Capitol View

The ordinances require “due consideration of the recommendations in the City of Madison Comprehensive Plan and any applicable, neighborhood, neighborhood development, or special area plan ...” Standard #9 requires the project to create “an environment of sustained aesthetic desirability compatible with the existing or intended character of the area ...” This proposal impinges on the view of the Capitol.

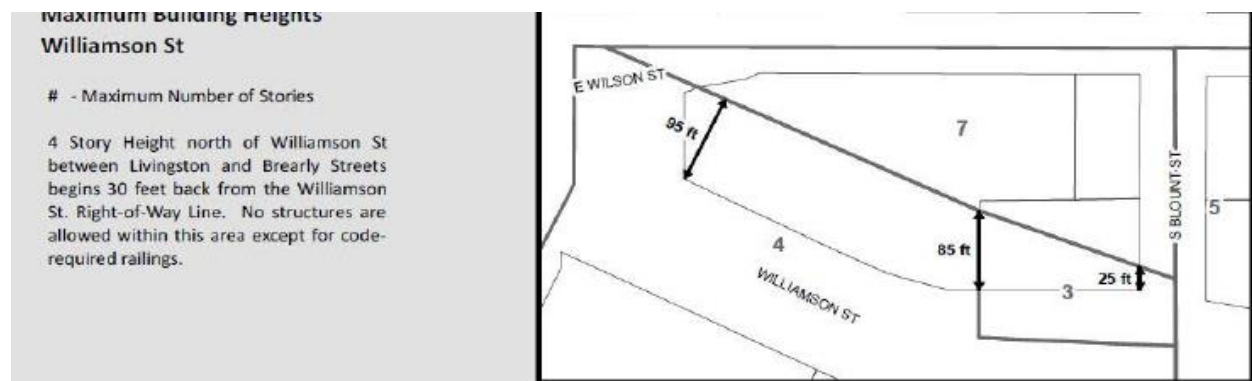
I question whether the perspective may be a bit off in the applicant’s massing study. For example, the proposed building is 40’ along Williamson, yet the orthogonal line running along Willy, when extended to 706 Willy, falls below the corresponding 40’ mark.

When I drop the building in, I get:

Small differences in the shift of perspective can create substantial changes.

#1, 727 Jenifer

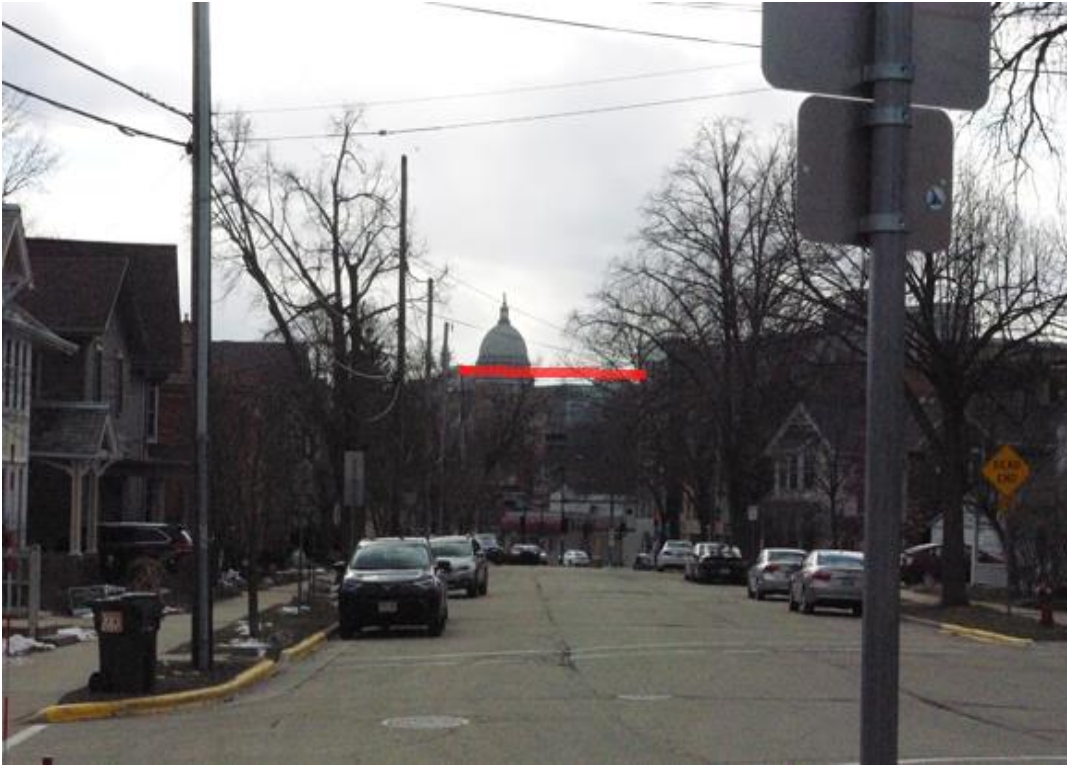
Attached are photos with lines added to approximate the obstruction of the Capitol view. For reference, the building at 706 Williamson has height measurement added along the building edge (which I took from the approved conditional use plans). The lines are not exact, but they provide a sense of how much of the Capitol view could be obstructed. Even the applicant's massing photos show obstruction from both sidewalks, so the street view of the Capitol would also be obstructed.
